PLANNING DEPARTMENT

CASE NO.: CUP-01309-2016

LOCATION: 28439 Foothill Drive (APN 2055-019-037)

REQUEST: Request for approval of a Conditional Use Permit to build a 3,647 square-foot, two-story single-family residence with a 56 square-foot basement, a 627 square-foot attached three-car garage and a 230 square-foot accessory structure; and to make a finding of exemption under the California Environmental Quality Act.

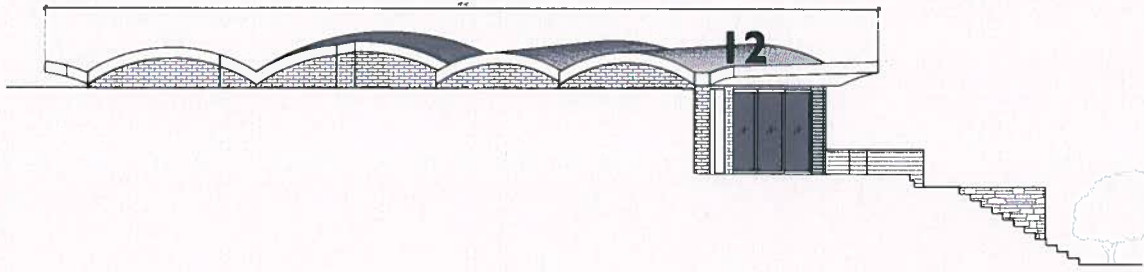
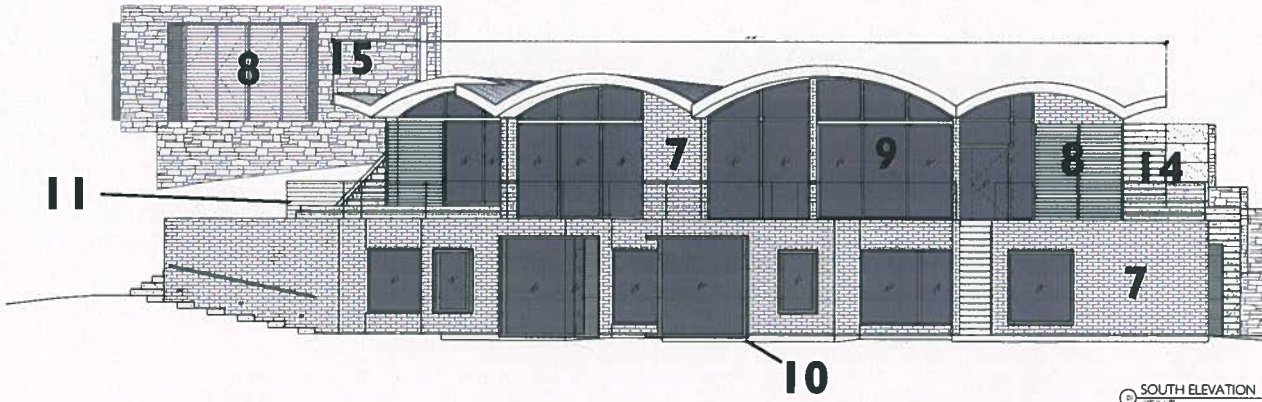
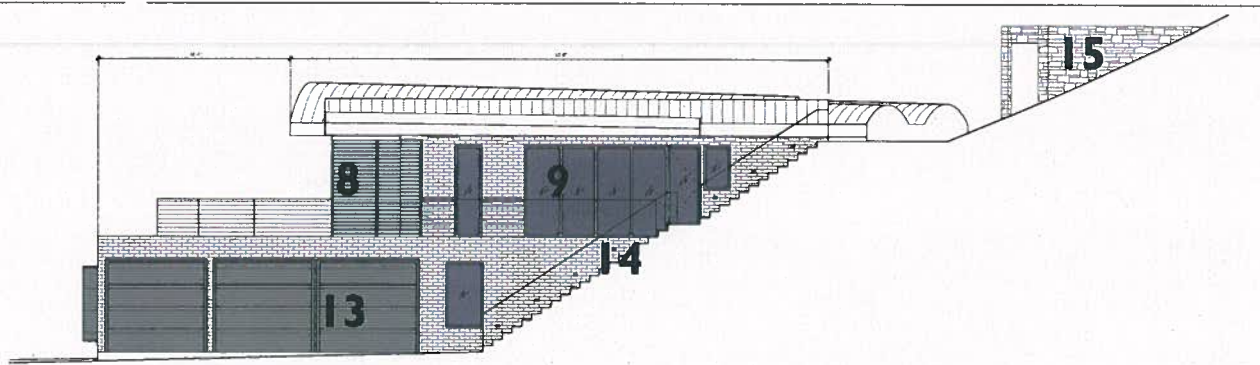
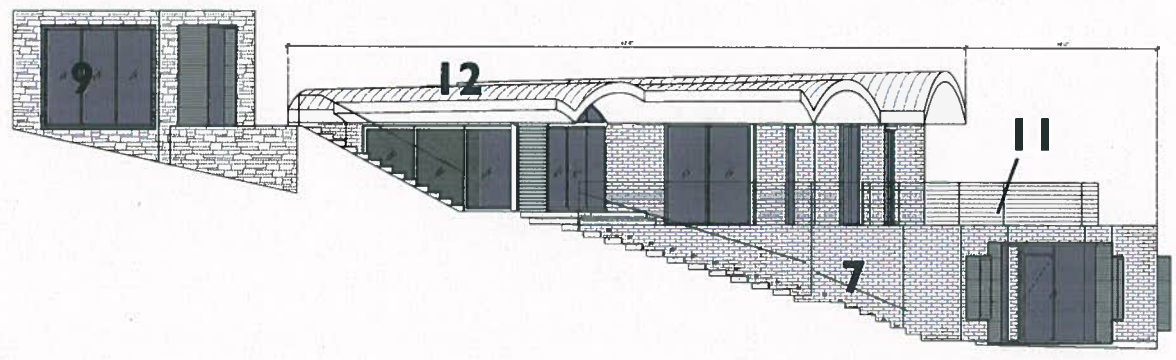
The Architectural Review Panel (ARP) reviewed the project. The ARP requested that a rendering of the residence be provided for the benefit of the Planning Commission. The ARP suggested the number of barrel roofs on the front elevation be reduced and more stone and natural materials be applied to the accessory structure to be more compatible with the single-family home. The applicant revised the plans in response. A rendering is attached to this report.

The proposed roof, was partially redesigned from the original version. One of the smaller "humps" was eliminated, and was replace with a larger one, reducing the "humps" from 5, to 4. Additionally, the water proofing membrane was replace with standing seam sheet metal.

Wood type trim was added to the front elevation around the windows for articulation, also, some wood shutter/horizontal details were added to the accessory structure.
